L-2003-239
10 CFR 50.90

Re: Turkey Point Units 3 and 4
Docket Nos. 50-250 and 50-251
Spent Fuel Pool Cask Area Rack Amendment
Clarification on RAI Response to NRC Questions 10a and 23

Clarification to the Response for RAI Question #23

Figure 1
Correct Unit 3 Rack Orientation

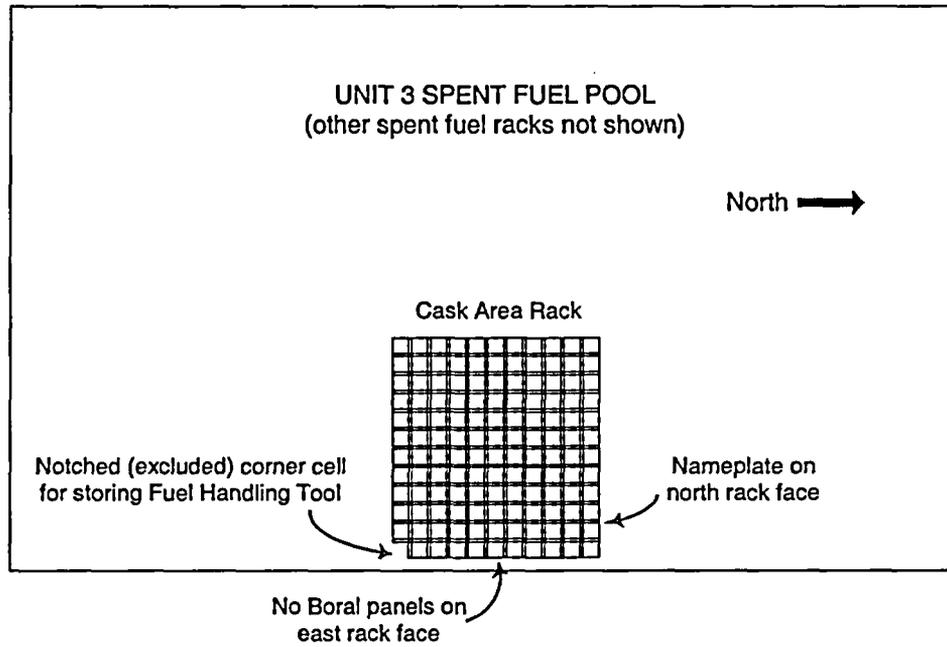
See Figures 1 and 2 on the following page for the correct rack orientation in the Unit 3 and Unit 4 spent fuel pools, respectively.

Note that on both units, the rack face with no Boral panels faces the east pool wall; the notched (excluded) corner cell is adjacent to the east pool wall; and the rack nameplate is on the north rack face.

- With the cask area rack on the leveling pad located under the cask handling crane, verify that the rack nameplate is facing north (the nameplate is located near the top of the north rack face, near the northeast corner).
- Verify that the nameplate reads "Turkey Point Unit 3". ["Unit 4" in the Unit 4 procedure]
- Verify that the notch (excluded cell) in the rack corner is in the southeast corner of the Unit 3 rack. [northeast corner of the Unit 4 rack]

2. Following rack installation in the spent fuel pool cask area, a QC hold point will require verification of the following step:
 - Verify by visual observation that the notch (excluded cell) is adjacent to the east pool wall, in the southeast corner of the Unit 3 rack. [northeast corner of the Unit 4 rack]
